**TRANSMISSION—4R44E OR 5R55E—SLIPPING
SHIFT/DELAYED OR NO ENGAGEMENT**

**Article No.
99-16-10**

FORD: 1999 EXPLORER, RANGER

MERCURY: 1999 MOUNTAINEER

Figure 1 - Article 99-16-10

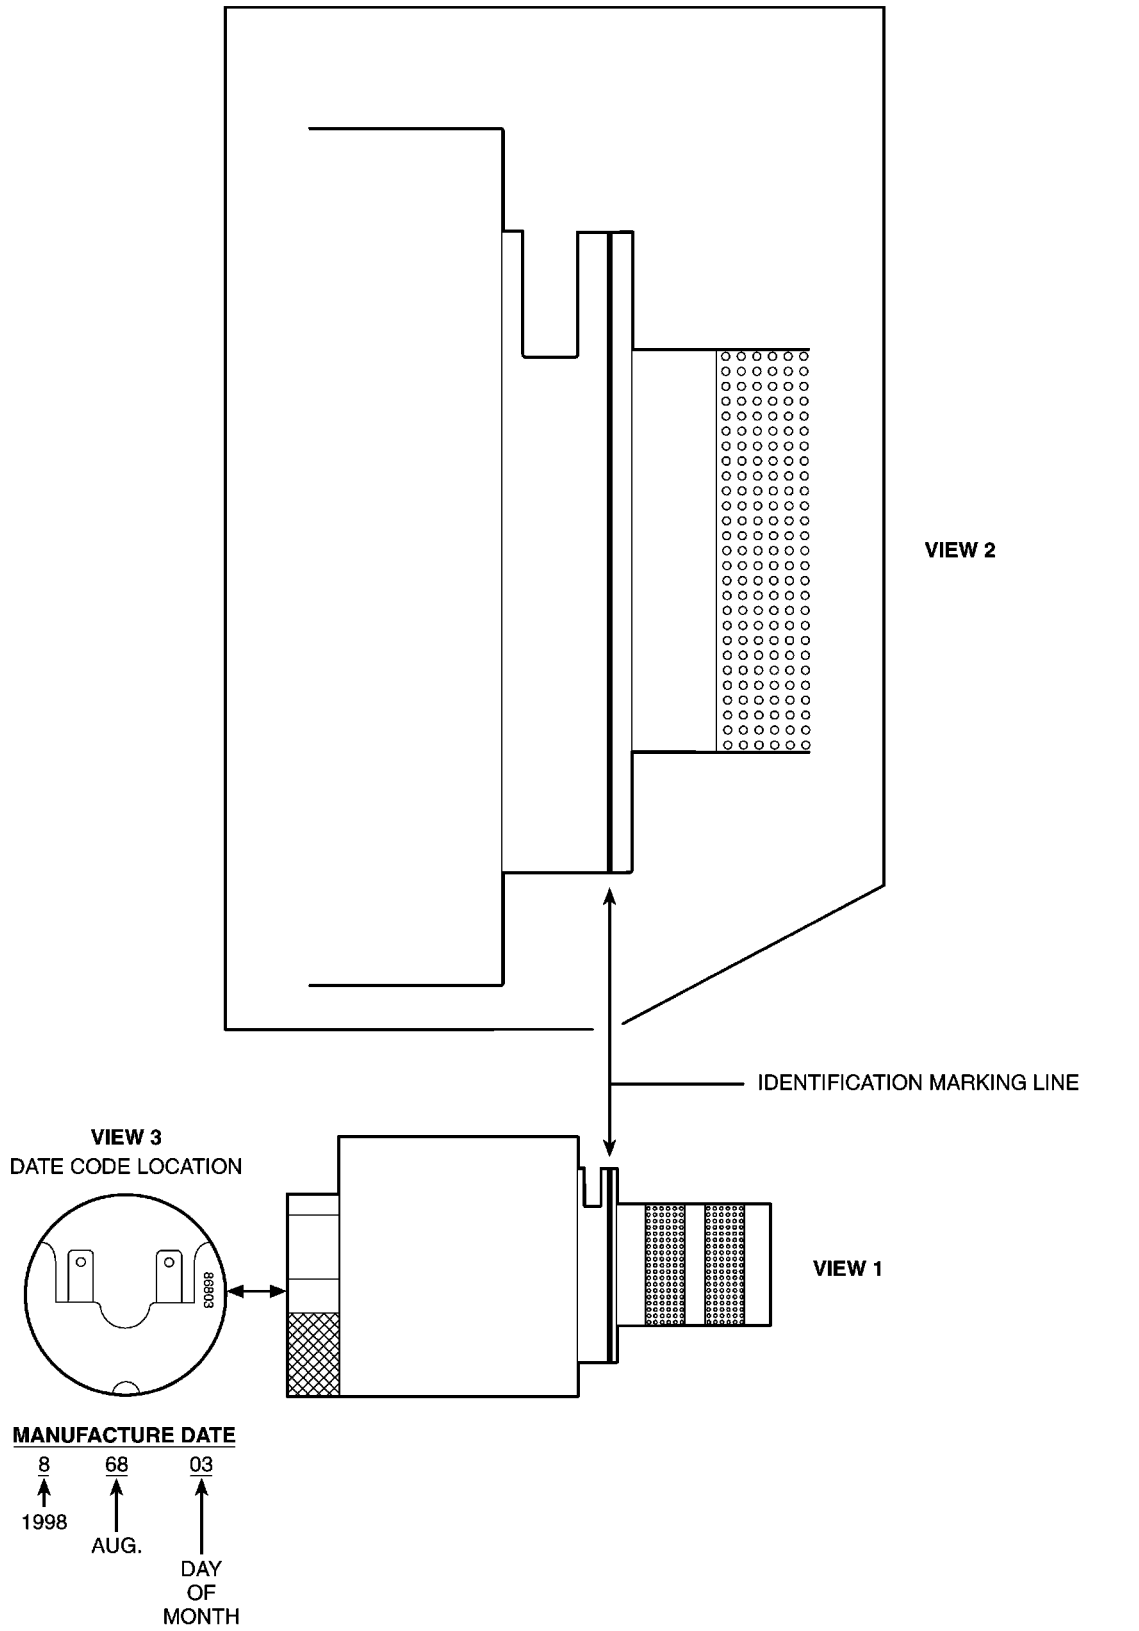
1. Perform normal diagnosis for this concern.
2. Perform Line Pressure Tests as listed in the 1999 Explorer/Mountaineer, Ranger Workshop Manual.
3. If pressures are low, perform Pinpoint Test for the EPC solenoid.
4. Inspect the bracket that attaches the Torque Converter Clutch (TCC), Shift Solenoid B (SSB), Shift Solenoid D/Coast Clutch Solenoid (SSD/CCS), and EPC solenoids to the main control for damage. If the bracket is damaged, replace both the bracket and solenoid.
5. If the bracket is not damaged, inspect the solenoid for the affected date code (refer to the following Manufacturing Date Code Chart) and ID marking (Figure 1, Views 1, 2, and 3). If the solenoid is one of the affected, replace it.

Diagnose and inspect for damaged EPC attachment bracket, and replace the bracket and EPC solenoid with new bracket and revised EPC solenoid. Refer to the following Service Procedure for details.
